ADDENDUM #1 - 6/16/2025
REVISED SHEETS: D-1, D-2, D-7, INT-2, INT-3, P-1, P-2, P-4, U-1, U-2, U-3, U-5, W-1, W-2, W-5, W-7, E-1, E-2, E-4, E-7, AND E-8.
REVISION #1 - 8/28/2025
REVISED SHEETS: D-6, INT-2, INT-3, INT-4, INT-6, INT-7, P-1, P-2, P-3, P-4, P-5, P-6, U, W, E, AND ALL X SHEETS.
REVISION #2 - 11/10/2025
REVISED SHEETS: D-6, D-7, INT 1 - INT 4, INT-6, P-1, P-2, P-4, U-1 - U-7, U-12 - U-15, W-3, X-1 - X-7, X-9, AND X-10.
REVISION #3 - 02/20/2025
REVISED SHEETS: U-1, U-4, U-13, U-14, W-1, AND W-7.

CITY OF MADISON
CITY ENGINEERING DIVISION
DEPARTMENT OF PUBLIC WORKS
PLAN OF PROPOSED IMPROVEMENT

E. MAIN STREET & S. HANCOCK STREET
ASSESSMENT DISTRICT - 2025

CITY PROJECT NO. 15125
CONTRACT NO. 8784

15125
D-1

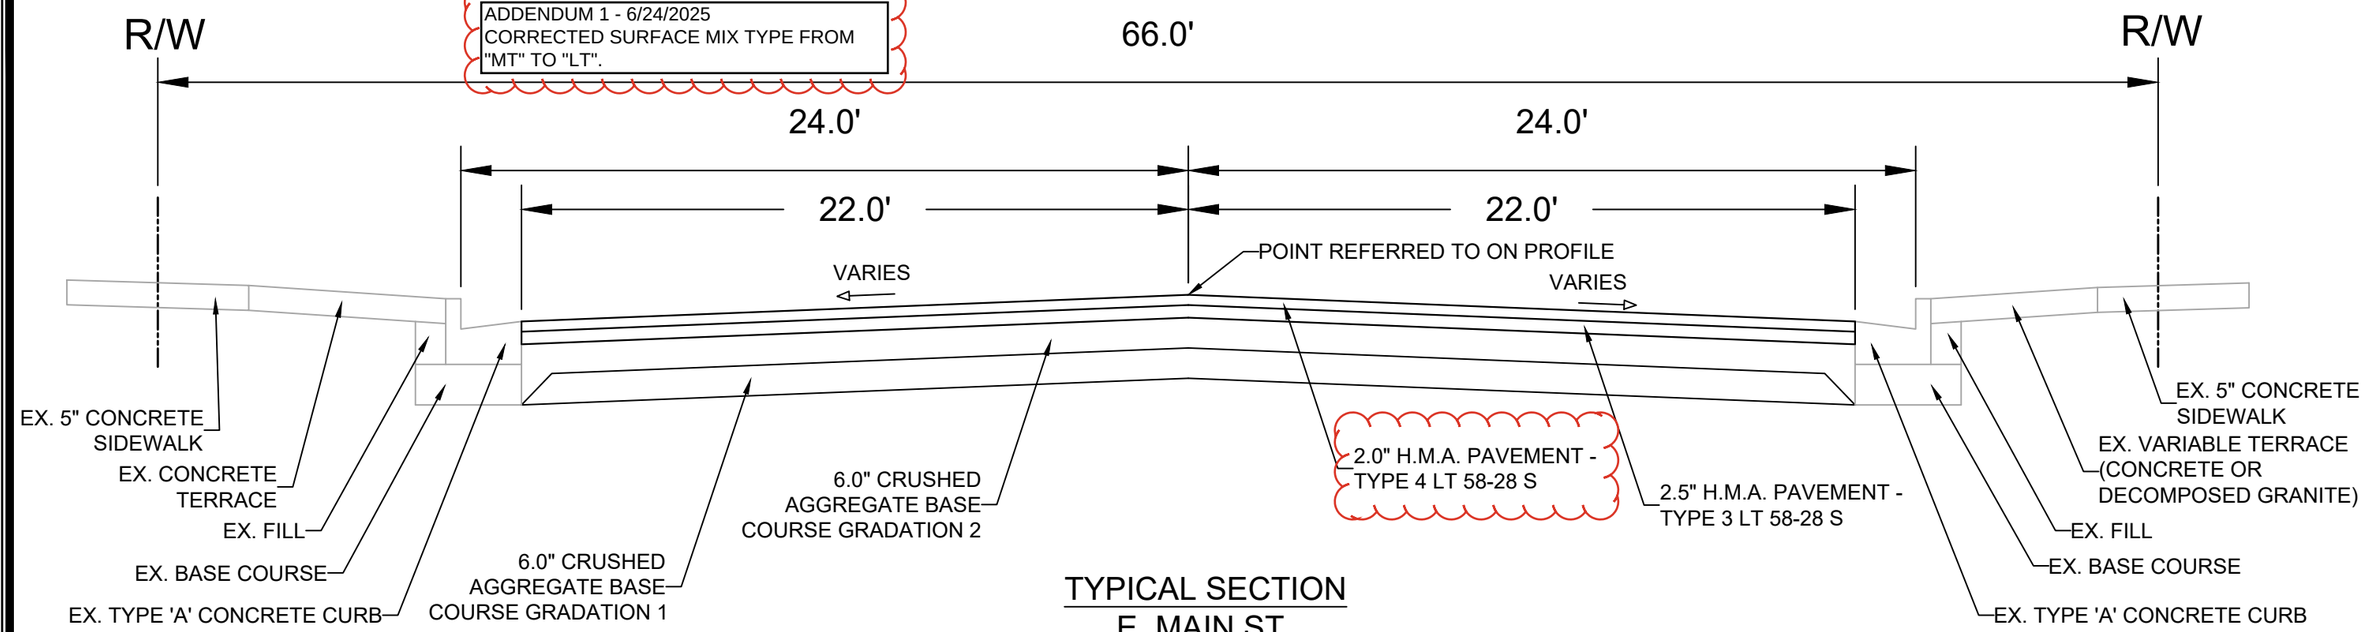
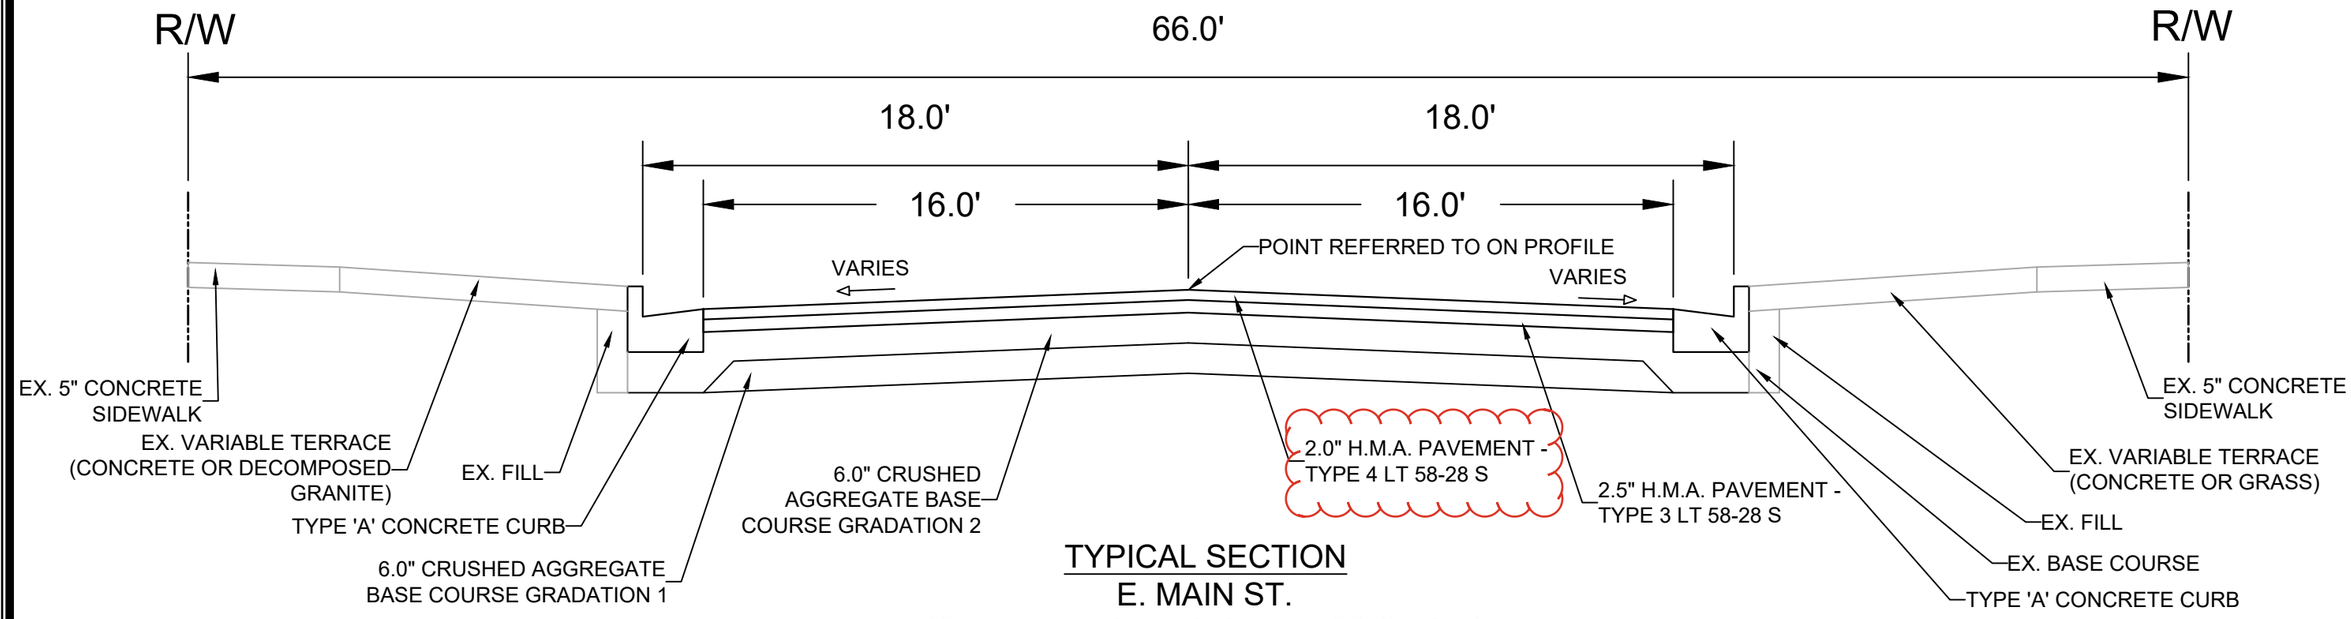
ADDENDUM 1 - 6/24/2025
CORRECTED SURFACE MIX TYPE FROM "MT" TO "LT".

15125
D-2

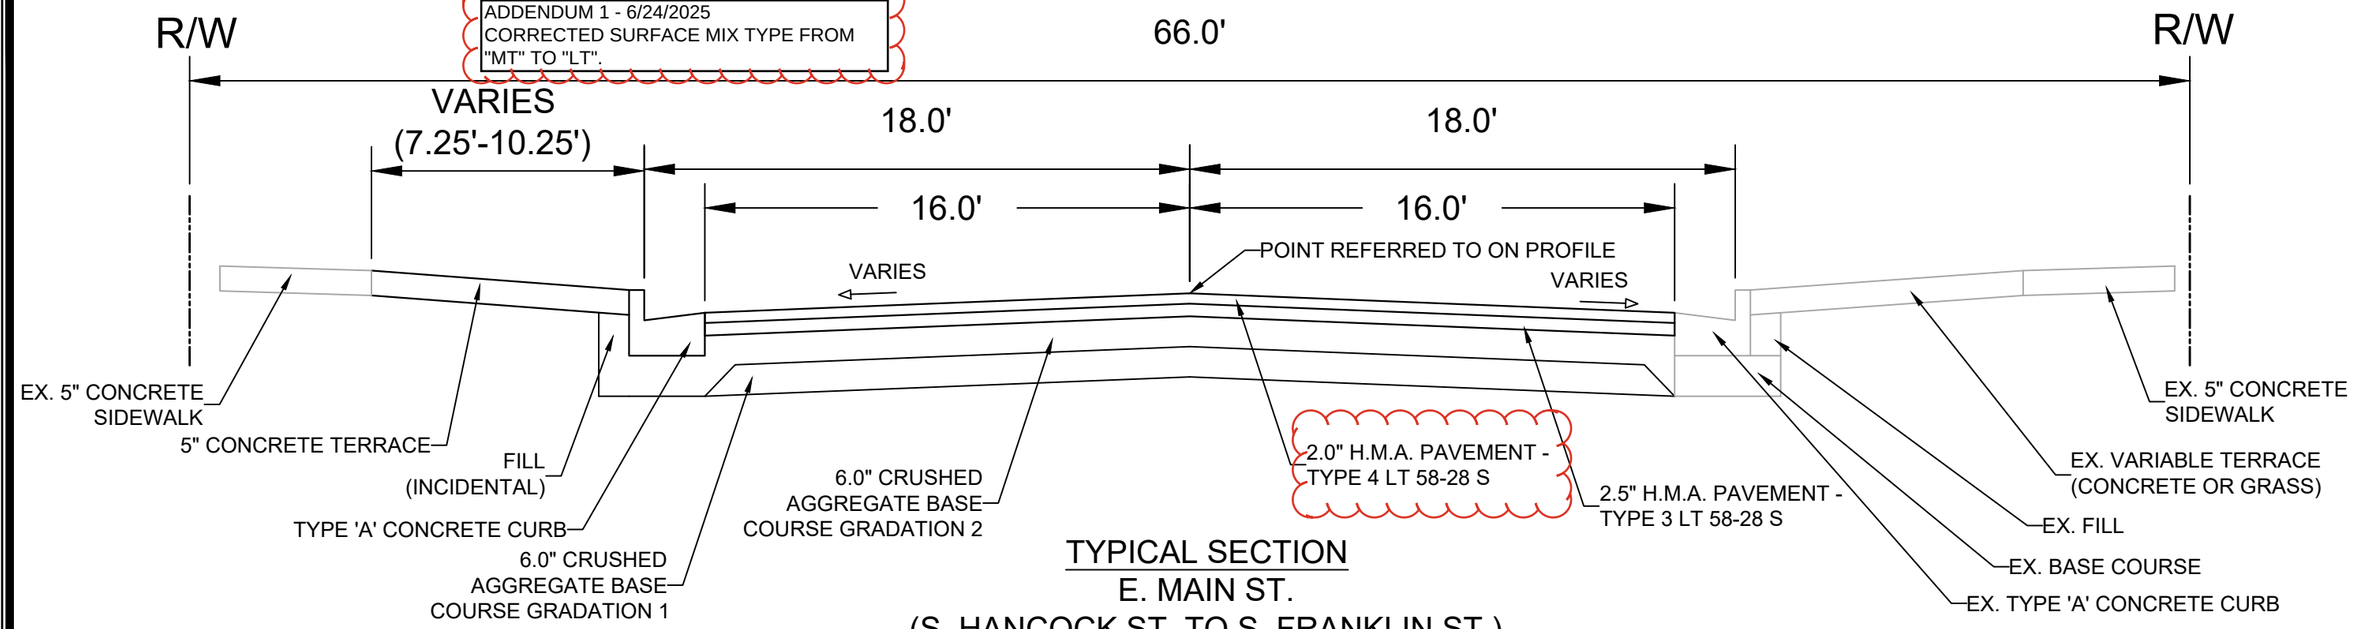
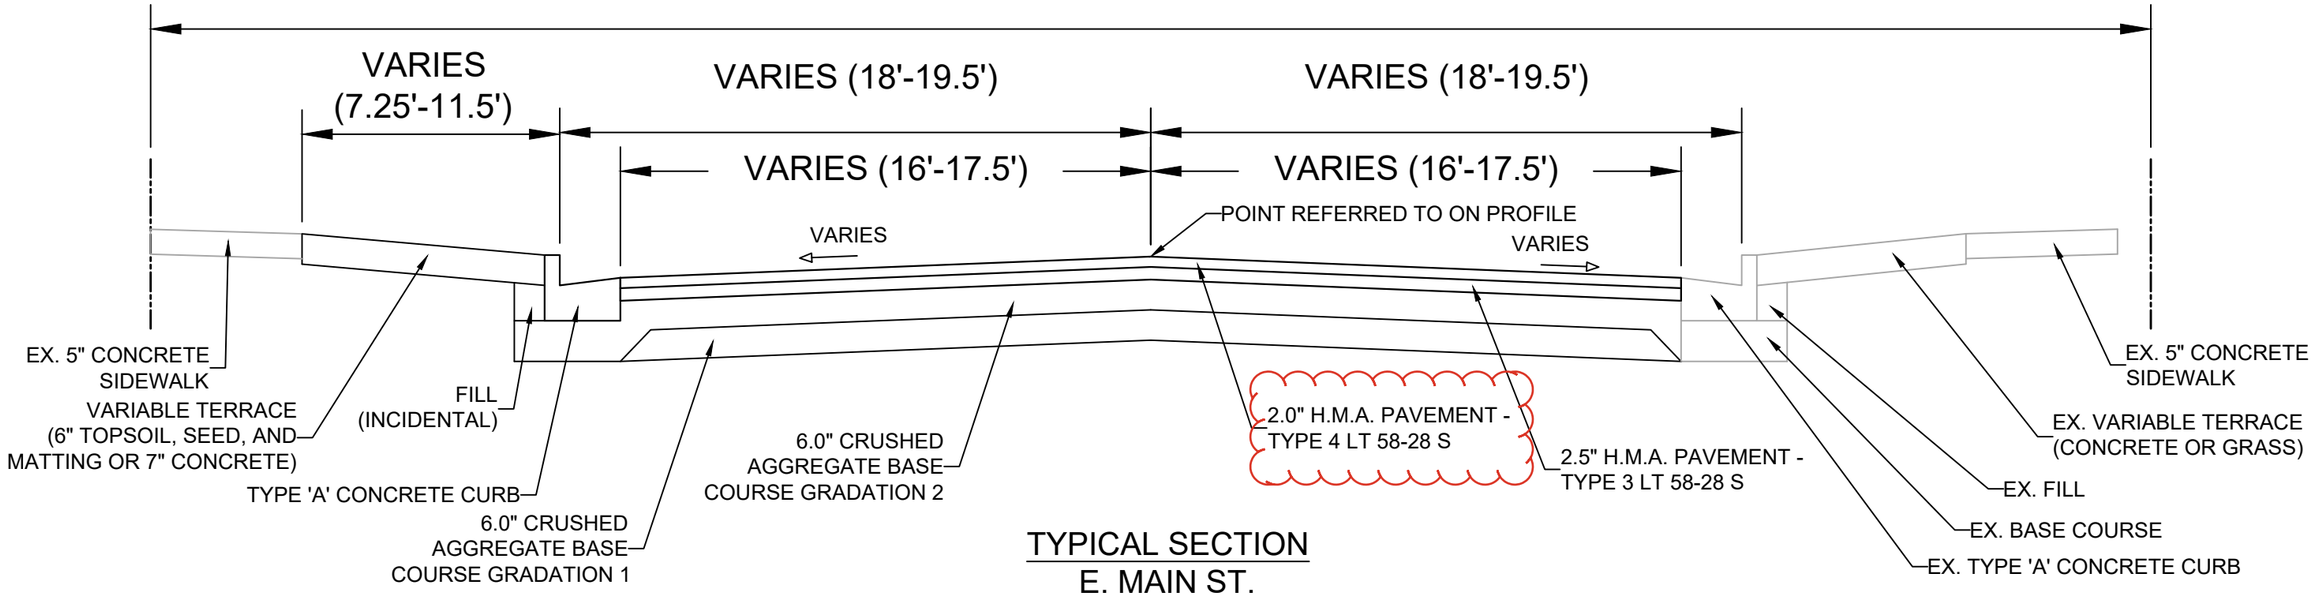
ADDENDUM 1 - 6/24/2025
CORRECTED SURFACE MIX TYPE FROM "MT" TO "LT".

15125
D-7

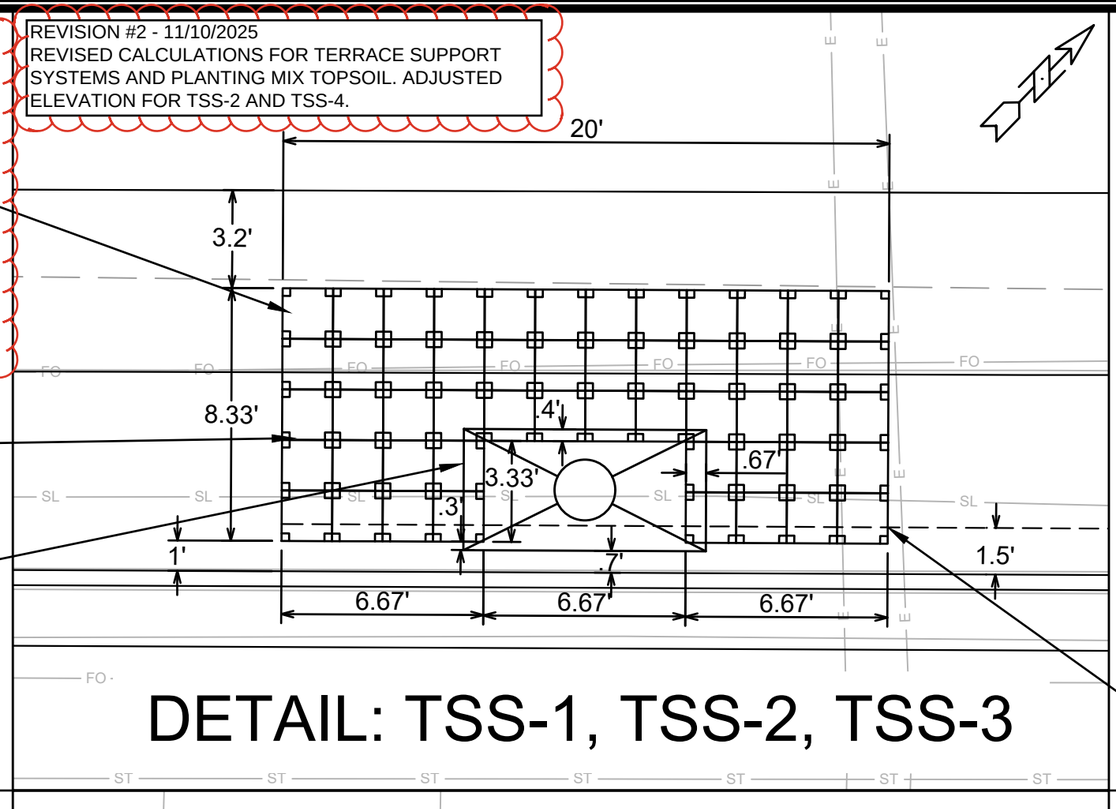
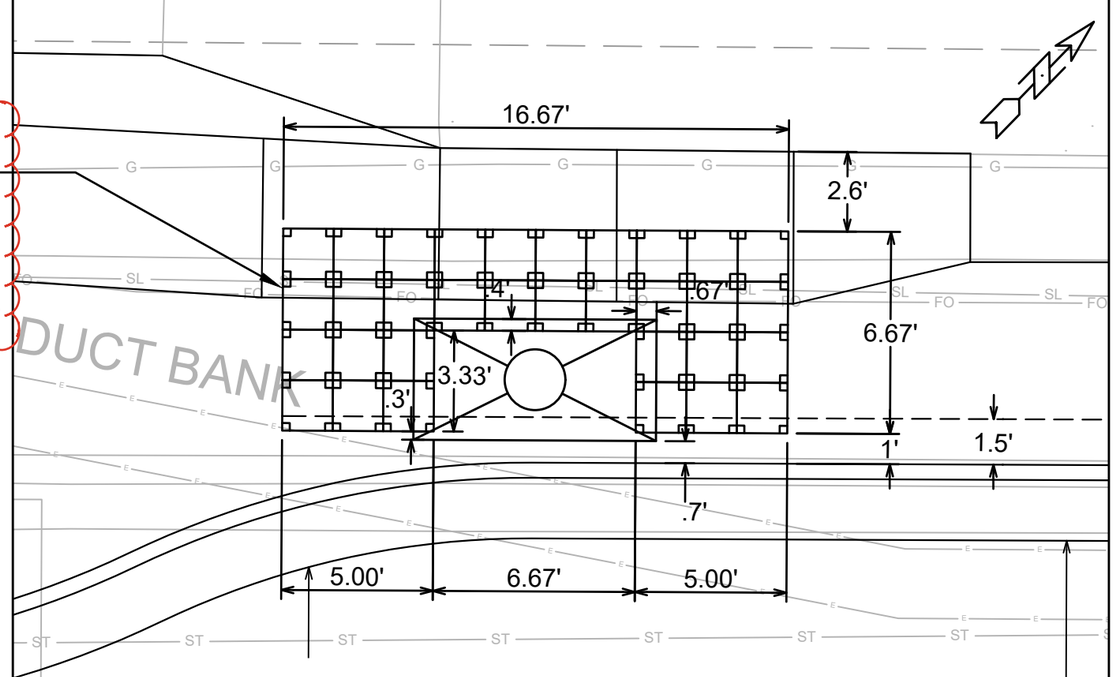
REVISION #2 - 11/10/2025
REVISED CALCULATIONS FOR TERRACE SUPPORT SYSTEMS AND PLANTING MIX TOPSOIL. ADJUSTED ELEVATION FOR TSS-2 AND TSS-4.

PM-7

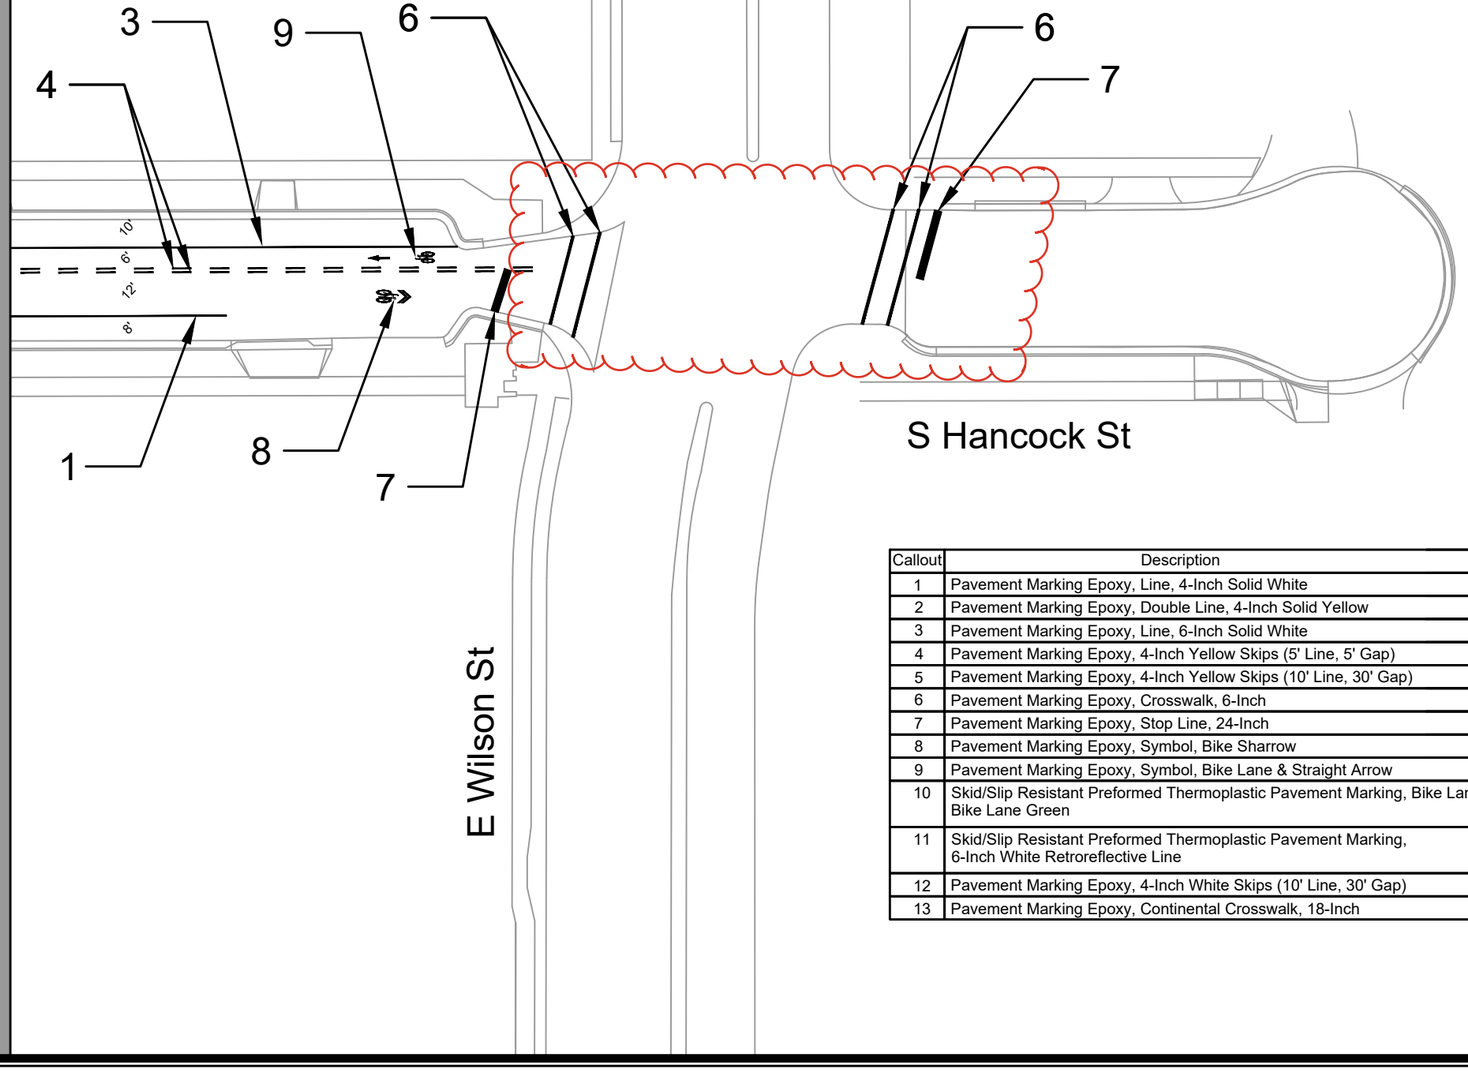
ADDENDUM 1 - 6/24/2025
1. INCREASED CURB REMOVAL/REPLACEMENT ON SOUTHWEST SIDE OF S. HANCOCK STREET.
2. ADJUSTED CROSSWALK MARKINGS TO MATCH EXISTING GEOMETRY.

14+25.00

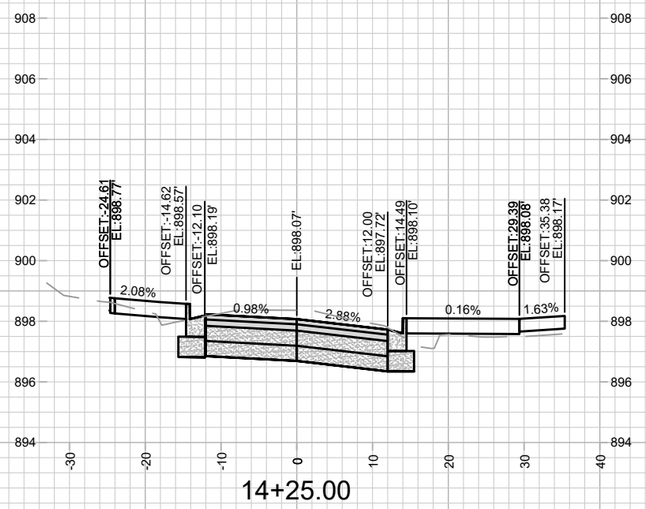
REVISION #2 - 11/10/2025
ADJUSTED LT EP.
